HORSHAM DISTRICT COUNCIL CONSULTATION

TO:	Horsham District Council – Planning Dept
LOCATION:	Phases 2 and 3 Land at Wellcross Farm Broadbridge Heath
DESCRIPTION:	Application for Approval of Details Reserved by Condition 2 (Construction Management Plan), ³ (borehole to meet Private Water Supplies), ⁴ (Private Water Supply Management Plan), ⁵ (finished floor levels and external ground levels) and 7 (underground services) to approved application DC/24/0205 Reserved matters application pursuant to condition 5 of outline planning permission DC/19/1897 for the provision of phases 2 and 3 of Land at Wellcross Farm to provide a continuing care retirement community with 94 units of accommodation (C2), with access, infrastructure, open space, landscaping and associated works including an onsite borehole water supply).
REFERENCE:	DISC/26/0012 & DISC/26/0013
RECOMMENDATION:	Advice / Modification / More information.
SUMMARY OF COMMENTS & RECOMMENDATION:

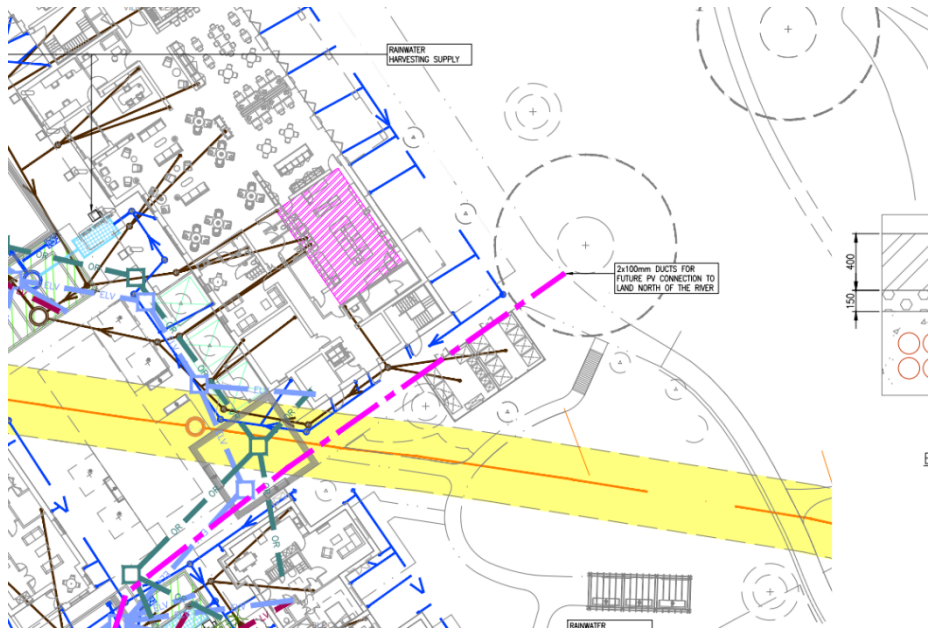
One arboricultural concern identified in the supporting documents accompanying the approval of details reserved by Condition 7 of the approved application DC/24/0205 relates to the route of the underground service pipes. These are proposed to pass through the Root Protection Area (RPA) of the off-site oak, T31, as numbered on the Tree Removal Plan Drawing No. 1164-KC-XX-YTREE-TRP01 Rev B that supported application DC/19/1897, as shown on the Electrical & Electrical Services Drawing No. 1163-ESD-XX-00-DR-XX-P2-1001. In addition, concerns are raised regarding the proposed landscaping works and associated land level changes in the area to the northwest of the off-site oak trees T30 and T31, as numbered on the Tree Removal Plan Drawing No. 1164-KC-XX-YTREE-TRP01 Rev B that supported application DC/19/1897.

If the new services are installed using an open-trench method, the historically greenfield nature of the site and the absence of physical constraints that would have limited root development to the northwest of the tree indicate a high likelihood that trenching works would result in substantial root severance and long-term damage to T31.

Given the greenfield nature of the site, it is essentially unconstrained. As such, it is not considered that there would be any *overriding justification* for significant development, such as open-trench excavations, to take place within the RPA of retained trees. Ideally, the site layout and design should take appropriate account of existing site constraints, including retained on-site and off-site trees.

Accordingly, amendments should be sought to the route of the service runs to ensure that they do not encroach within the RPA of tree T31, and outside of the RPA, of the unknown tree in the above image taken from Electrical & Electrical Services Drawing No. 1163-ESD-XX-00-DR-XX-P2-1001.

One potential solution would be to relocate the service runs further north, outside the RPA of T31, and outside of the RPA, of the unknown tree in the above image. If this is not considered feasible, trenchless installation methods should be employed, such as thrust boring or impact moling.

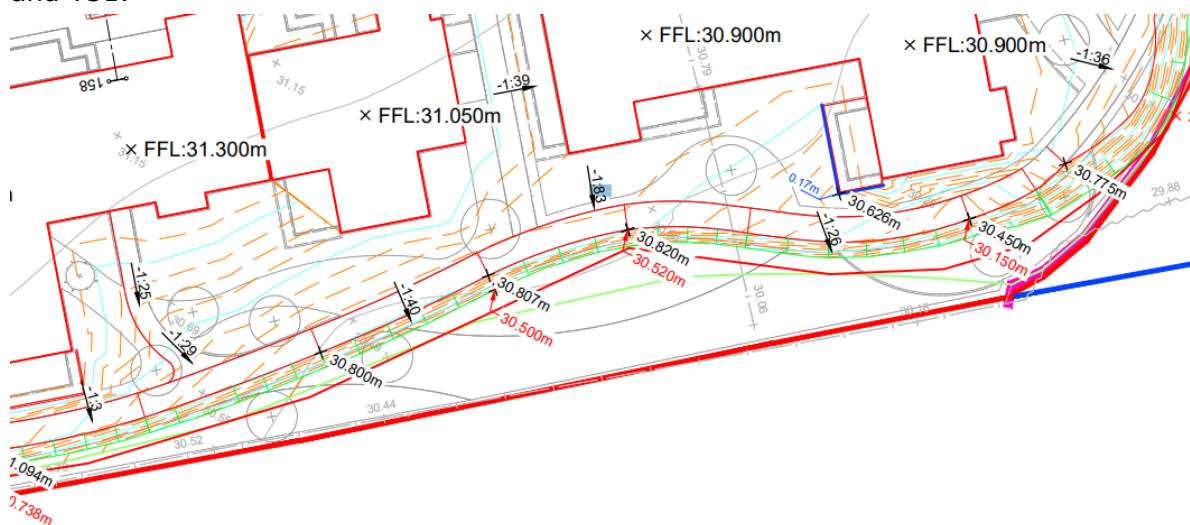
Further concerns are also raised in relation to the proposed landscaping works and associated land level changes in the area to the northwest of off-site trees T30 and T31, both oaks. Given the lack of detail on how the works would be completed without resulting in direct construction damage or indirect post-development harm, including root damage and soil compaction, these proposals are considered problematic. Please seek confirmation on the exact extent of the level changes and landscaping works within the RPA of T30, and T31.
